STAFF RECOMMENDATION
1415 Forrest Avenue
March 19, 2014

Application: New construction - outbuilding
District: Lockeland Springs-East End Neighborhood Conservation Zoning Overlay
Council District: 06
Map and Parcel Number: 08309036600
Applicant: Amy Thran, Owner
Project Lead: Sean Alexander, sean.alexander@nashville.gov

<p>Description of Project: The applicant proposes to construct a new two-car garage with a “bonus room” above.</p> <p>Recommendation Summary: Staff recommends approval of the proposed outbuilding with the condition that Staff approves the window and door selections, finding it to meet the applicable sections of the design guidelines for the Lockeland Springs-East End Neighborhood Conservation Zoning Overlay.</p>	<p>Attachments A: Photographs B: Site Plan C: Elevations</p>
---	--

SITE PLAN
© S.A.B. HAGER
ARCHITECTURE
8 MARCH, 2014

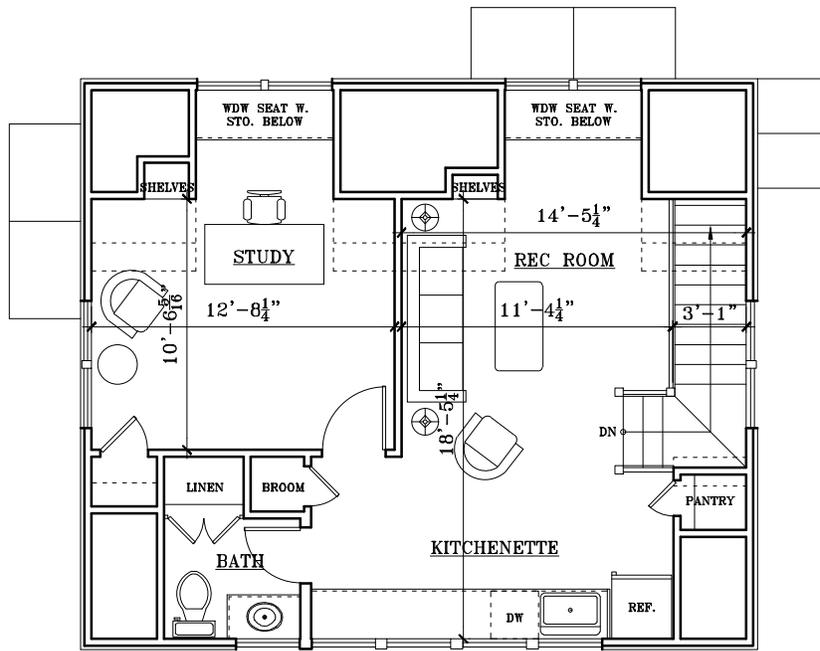
The new building will be located behind the primary building, with garage doors facing the alley at the rear of the property. The structure will be set ten feet (10') in from the rear property line, eight feet (8') from the right boundary and roughly thirteen feet (13') from the left. This location is compatible with the location of historic outbuildings and meets the bulk zoning setback requirements. The project meets guideline II.B.8.b, as well as guidelines guideline II.B.3. The orientation of the building will also match that of the primary building, and will meet guideline II.B.6.

ELEVATIONS
© S.A.B. HAGER
ARCHITECTURE
8 MARCH, 2014

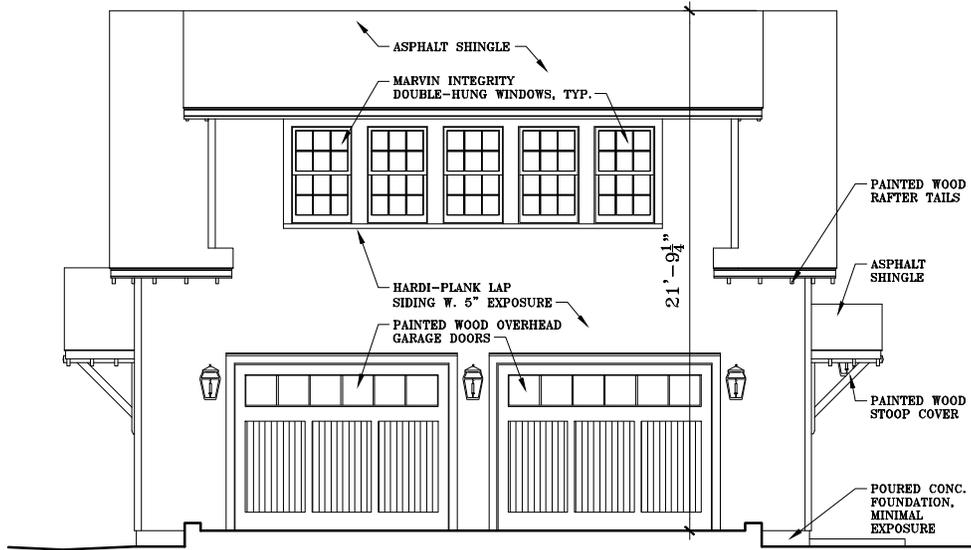
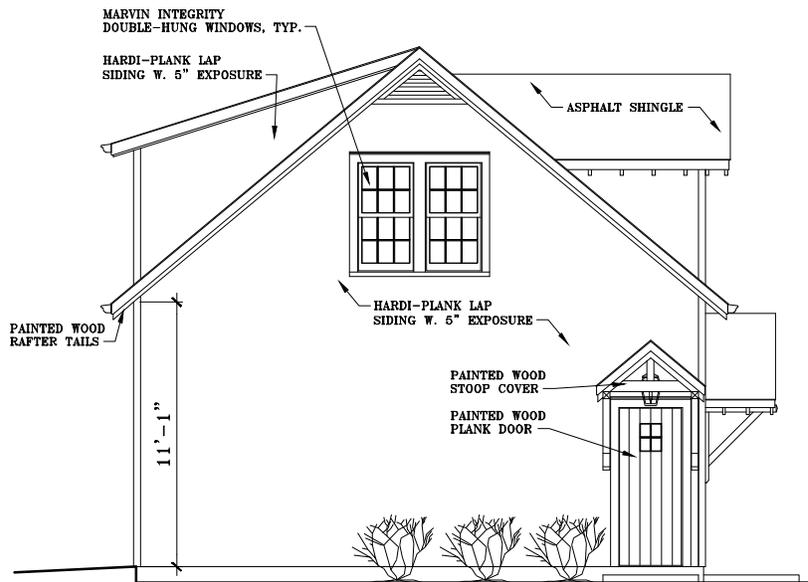
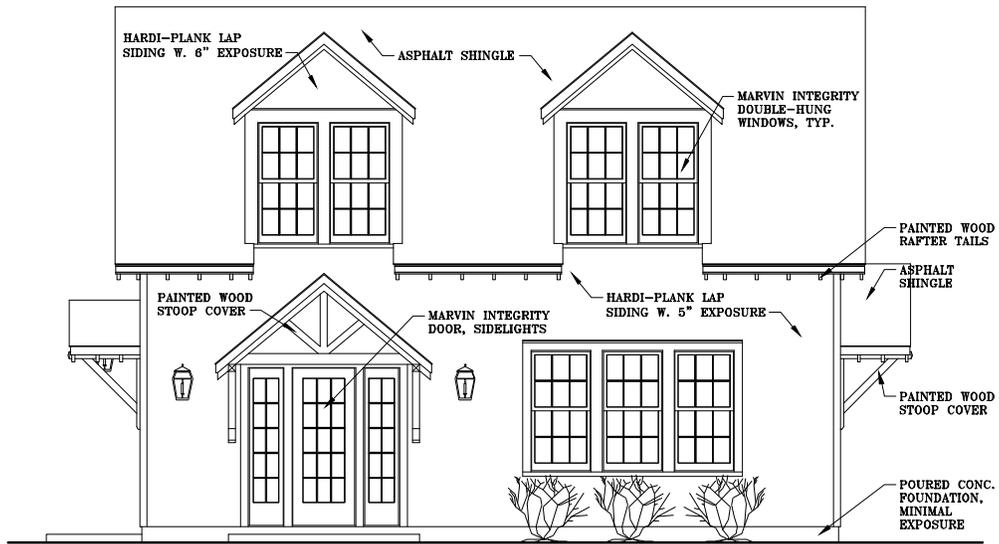
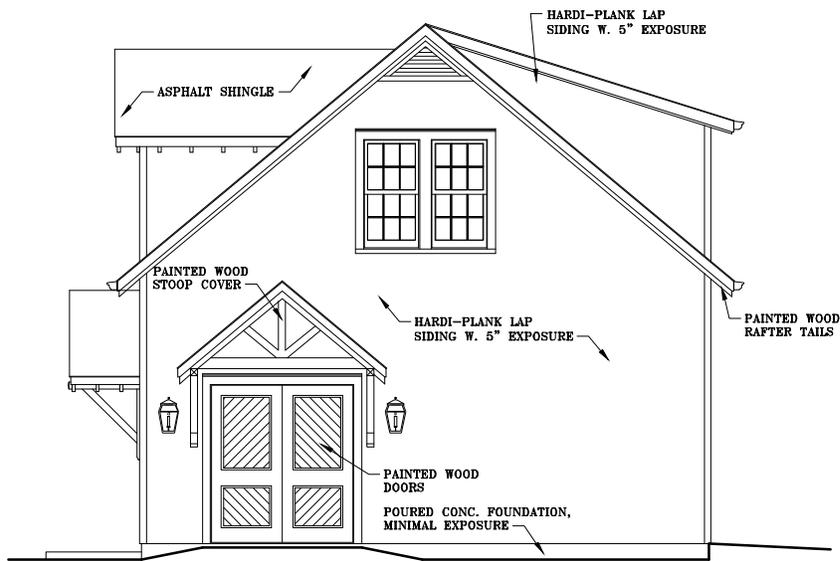
The new garage will be twenty-two feet (22') tall, with a first-story wall height of eleven feet, one inch (11'-1"). The height is lower than the ridge of the roof on the house by three feet (3'). The eaves will overhang the walls and extend to a point ten feet, six inches (10'-6") above grade.

The garage will primarily be clad in smooth faced cement fiberboard with a reveal of five inches (5"). The trim will be wood. The foundation will be poured concrete, and the roof will be fiberglass shingles in a color to match the existing roof. The windows will be fiberglass and the doors will be wood, and staff asks to approve the final window and door selections. With the staff's final approval of the windows and doors, staff finds that the known materials meet guideline II.B.4.

The primary roof of the new outbuilding will be a side-oriented gable with a pitch of 10:12. The front of the building, on the elevation facing the street, will have a pair of gabled dormers with the same pitch. The rear slope of the roof will have a shed-dormer with a 4:10 pitch. These roofs are compatible with similar surrounding buildings and meet guideline II.B.5.

The windows on the proposed addition are all generally twice as tall as they are wide, thereby meeting the historic proportions of openings. There are no large expanses of wall space without a window or door opening. Staff finds the project's proportion and rhythm of openings to meet Section II.B.7.

Staff recommends approval of the proposed outbuilding with the condition that Staff approves the window and door selections, finding it to meet the applicable sections of the design guidelines for the Lockeland Springs-East End Neighborhood Conservation Zoning Overlay.
